Item Name: Fwd Crosstube - High 407

DART AEROSPACE LTD		Work Order: 147192
Description: Crosstube High Fwd (407)		Part Number: D407-667-105
Inspection Dwg: D407-667-145	Rev: C	Page 1 of 1

DRAWING NO. D407-667-145	TITLE CROSSTUBE ASS'Y (407 HIGH FWD)	REV. C	DART AEROSPACE LTD ENGINEERING ORDER		D.E.O. NO. D407-667-145-C-1	SHEET NO. SHEET 1 OF 1	SCALE NTS
DRAWN qp	CHECKED ASS		MFG. APPR. [Signature]	APPROVED [Signature]	DE APPR. [Signature]	DATE 11.07.21	
DATE 11.07.15	DATE 11.07.22		DATE 11.07.22	DATE 11.07.22	DATE 11.07.21

DRAWING NO. D407-667-145	TITLE CROSSTUBE ASS'Y (407 HIGH FWD)	REV. C	DART AEROSPACE LTD ENGINEERING ORDER	D.E.O. NO. D407-667-145-C-2	SHEET NO. SHEET 1 OF 1	SCALE NTS
DRAWN AJS	CHECKED	MFG. APPR.	APPROVED	DE APPR.		
DATE 12.08.02	DATE 12.08.02	DATE 12.08.02	DATE 12.08.02	DATE 12.08.02

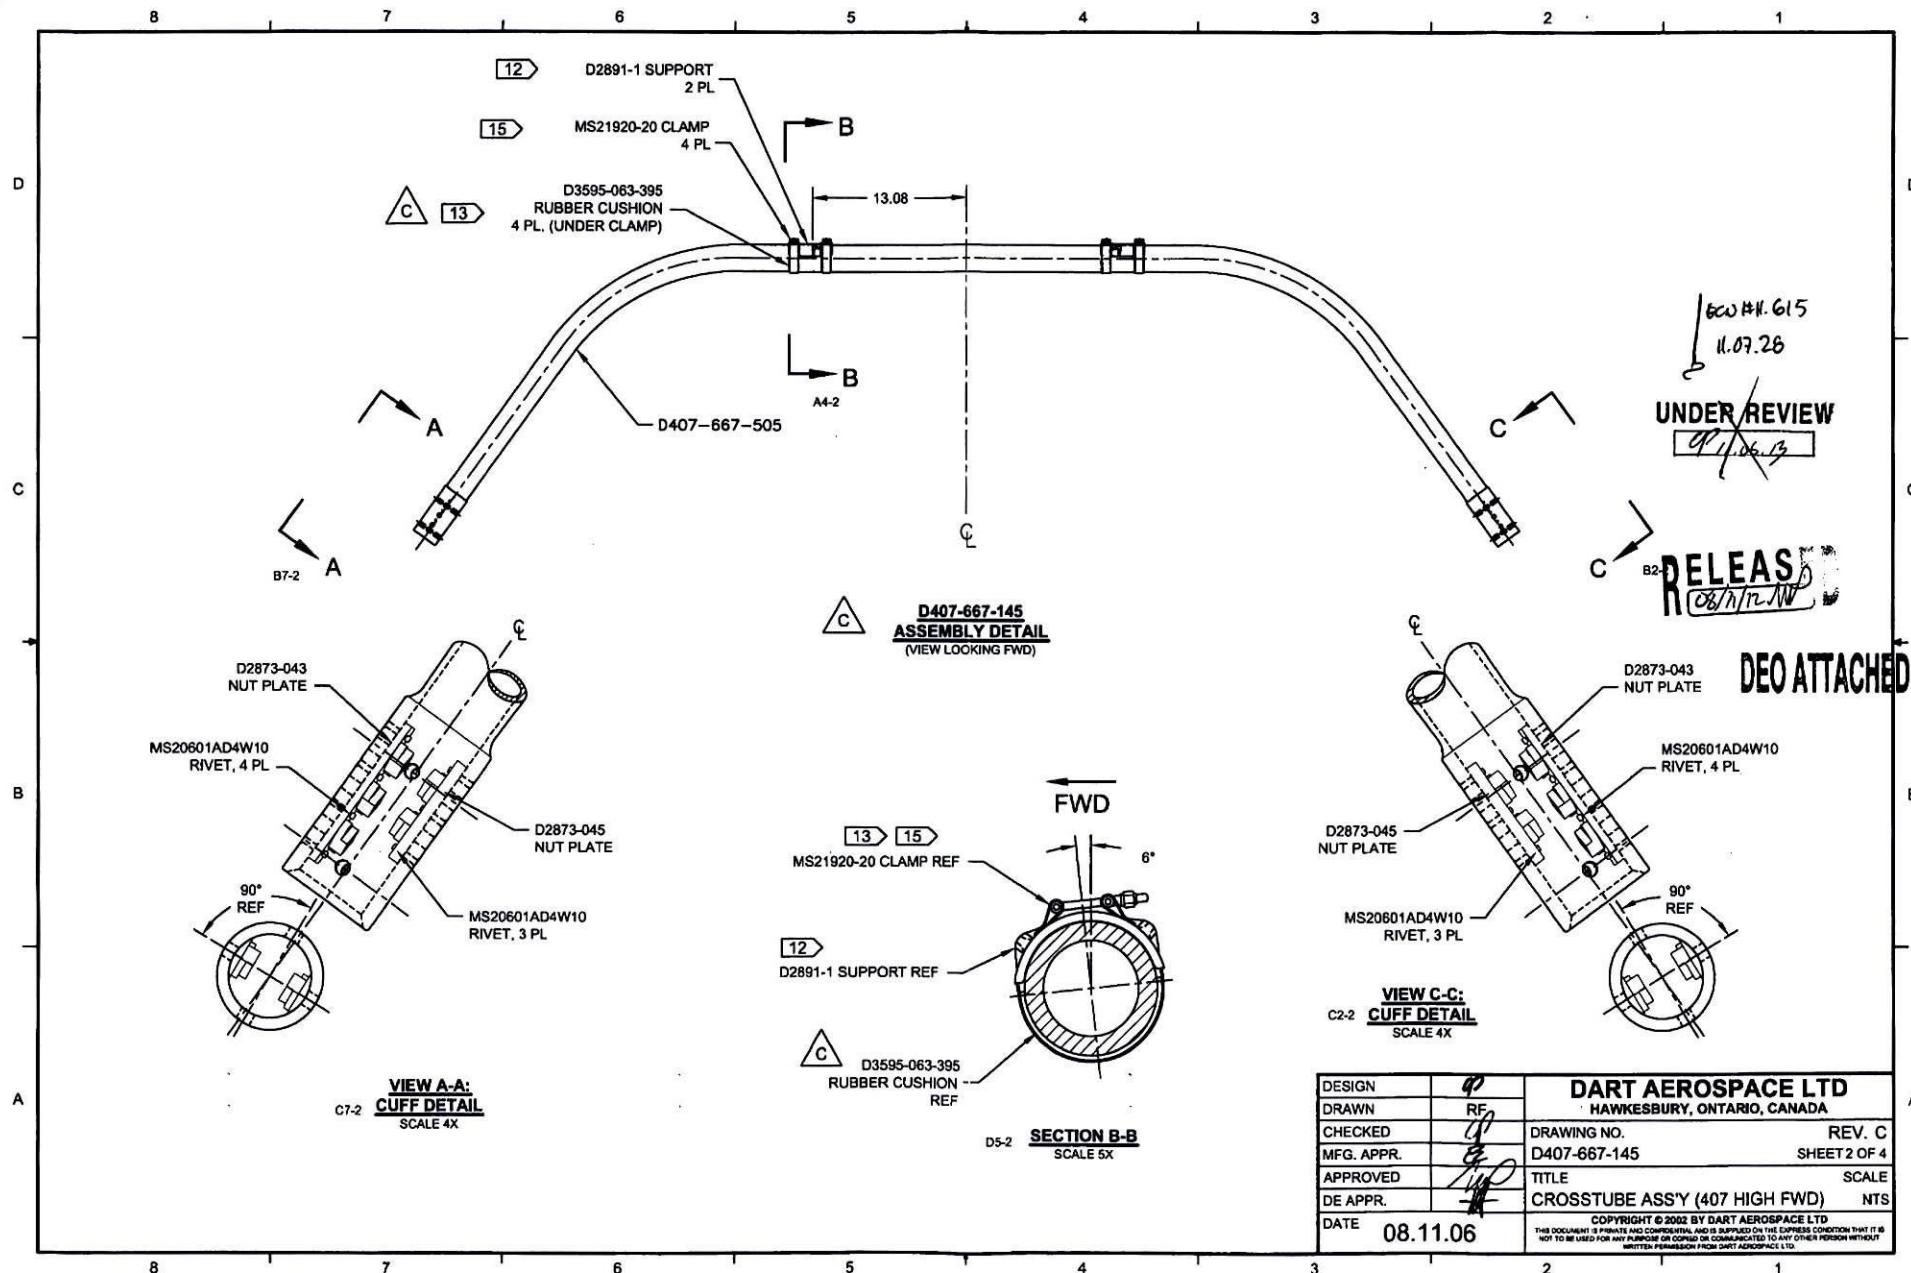
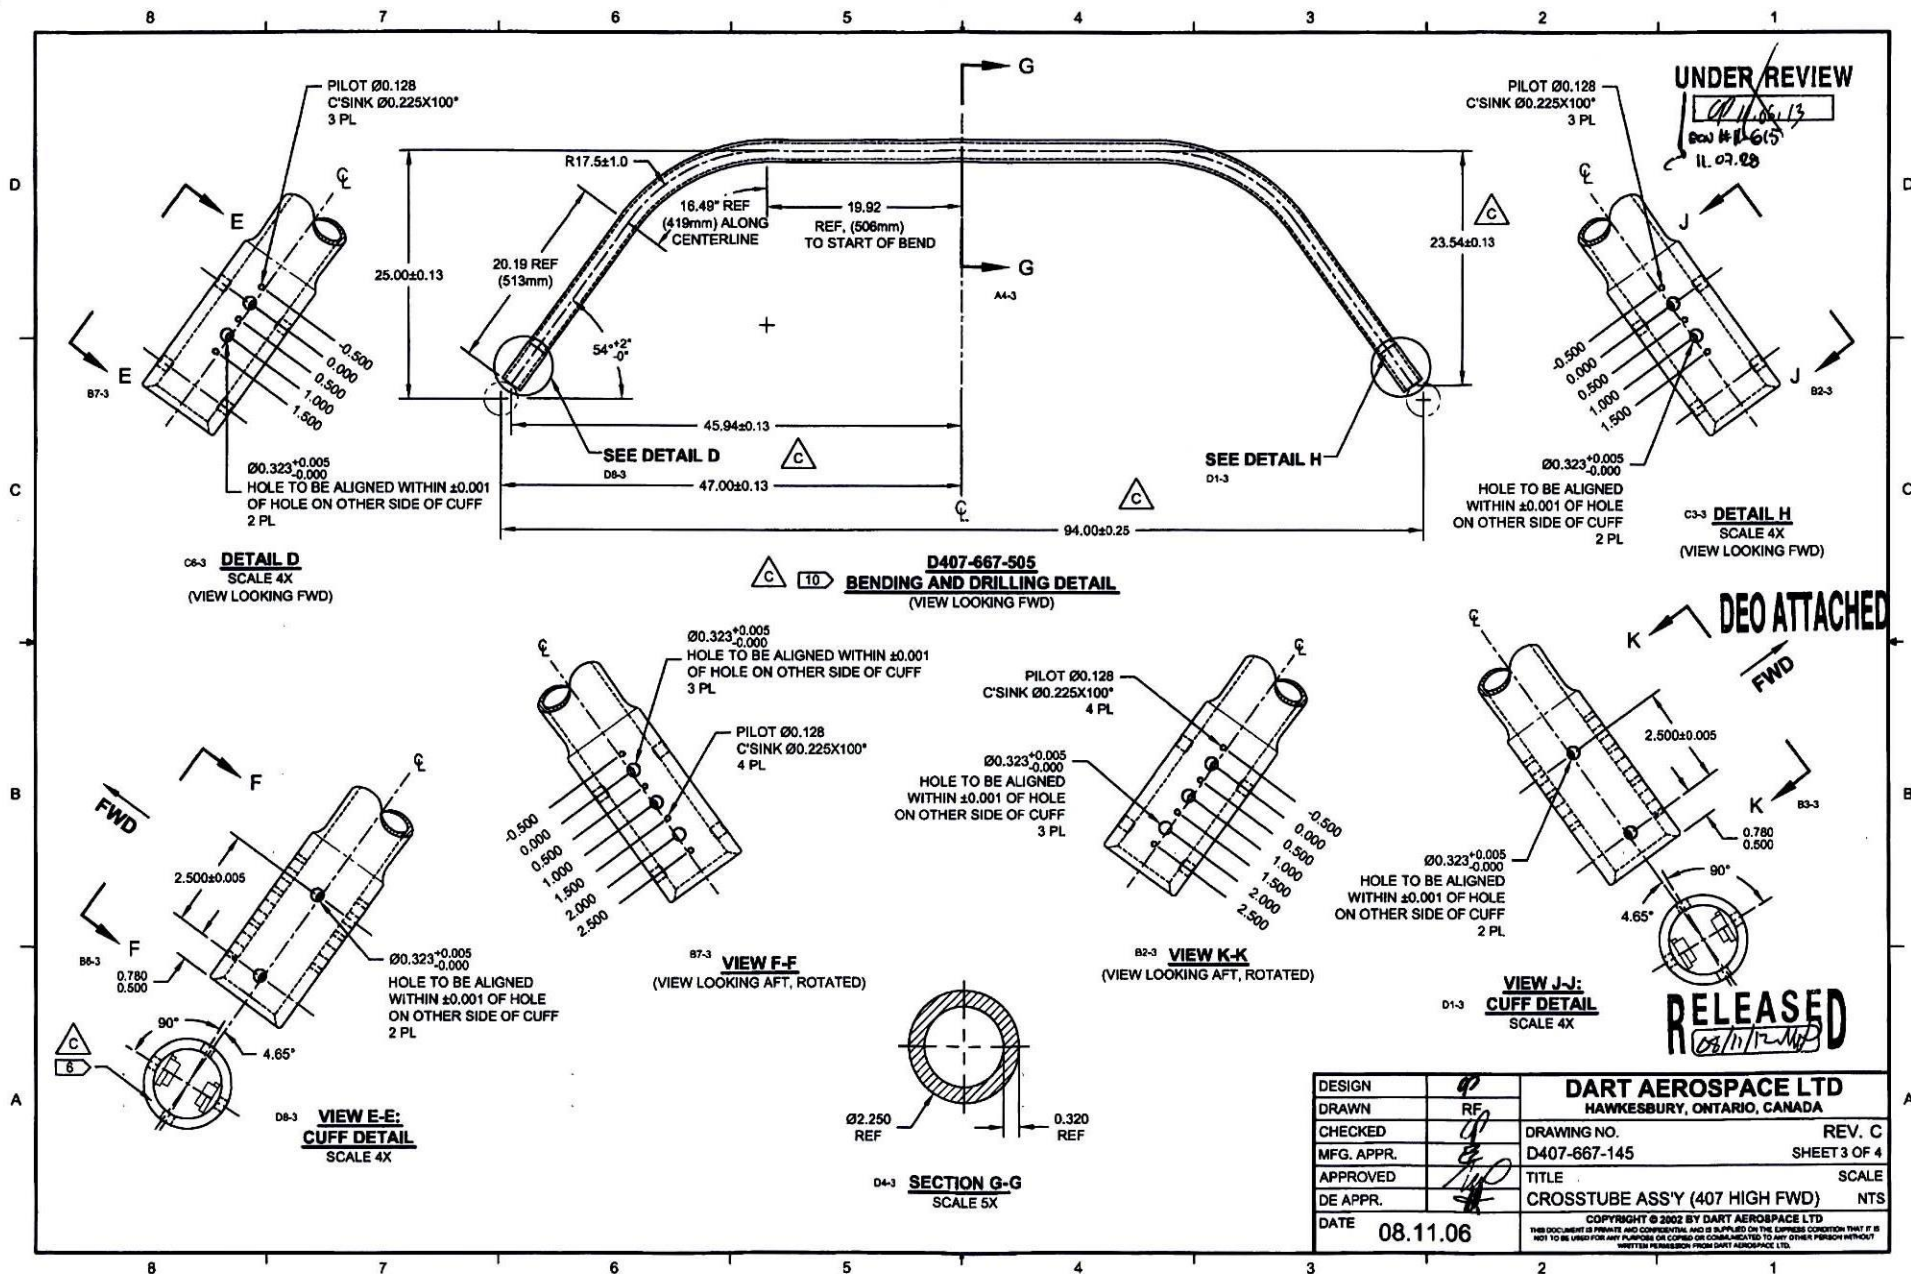
PURPOSE:
REPLACE MAGNOBOND WITH PROSEAL.

Item	Qty	Part Number	Description
9	A/R	PROSEAL 890 B-2	SEALANT, AMS-S-8802 CLASS B-2

9	A/R	MAGNOBOND 6398	ROCKWELL SPECIFICATION RBO-120-023 ADHESIVE (TEXTRON/BELL SPEC. 299-947-100, TYPE II, CLASS 2 ADHESIVE)
---	-----	----------------	---

12) INSTALL D2891-1 SUPPORT USING 0.03" TO 0.06" THICK LAYER OF MAGNOBOND 6398 PER QSI 015. LET CURE FOR 12 HOURS AFTER INSTALLATION AND PRIOR TO PACKAGING.

15) TORQUE CLAMPS 80 TO 100 IN-LB. ENSURE AT LEAST 1.5 THREADS SHOWING IN SAFETY AND THAT NUT HAS NOT BOTTOMED-OUT AFTER TORQUING.

12) TO INSTALL D2891-1 SUPPORT: ABRASE MATING SURFACE OF SUPPORT AND CROSSTUBE WITH 180-GRIT SANDPAPER AND REMOVE RESIDUE WITH MEK (OR EQUIVALENT). APPLY A 0.04" TO 0.07" THICK LAYER OF PROSEAL 890 CLASS B-2 (OR AMS-S-8802 CLASS B-2) SEALANT TO MATING SURFACE OF SUPPORT.

15) TORQUE CLAMPS 80 TO 100 IN-LB. ENSURE AT LEAST 1.5 THREADS SHOWING IN SAFETY AND THAT NUT HAS NOT BOTTOMED-OUT AFTER TORQUING. **PRIOR TO PACKAGING, RE-CHECK TORQUE ON CLAMPS AFTER PROSEAL 890 SEALANT HAS CURED FOR 72 HOURS.**

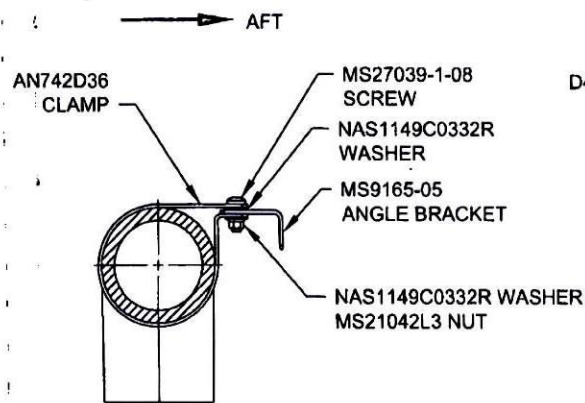
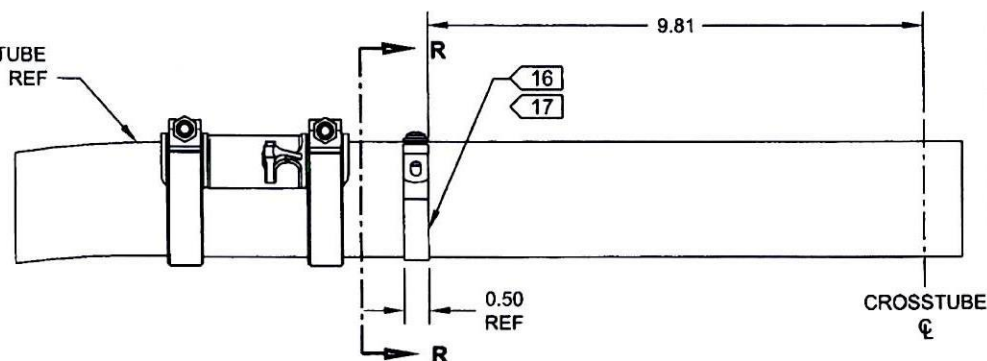
ADD ELECTRICAL GROUNDING STRAP

ITEM	QTY	PART NUMBER	DESCRIPTION
1	X	D407-667-145	CROSSTUBE ASSEMBLY (407 HIGH FWD)
10	2	AN742D36	CLAMP
11	2	MS9165-05	ANGLE BRACKET
12	2	MS21042L3	NUT (OR MS21042-3)
13	2	MS27039-1-08	SCREW
14	4	NAS1149C0332R	WASHER (OR AN960C10L)

- 16) MASK AREA UNDER CLAMP PRIOR TO PAINTING
- 17) SEAL EDGES WHERE AN742D36 CLAMP MEETS WITH THE CROSSTUBE USING SIKAFLEX-241/-291 OR MIL-S-8802 CLASS B2 OR PROSEAL 890 SEALANT
- 18) PERFORM RESISTANCE CHECK TO ENSURE MAX RESISTANCE IS 10 MILLIOHMS
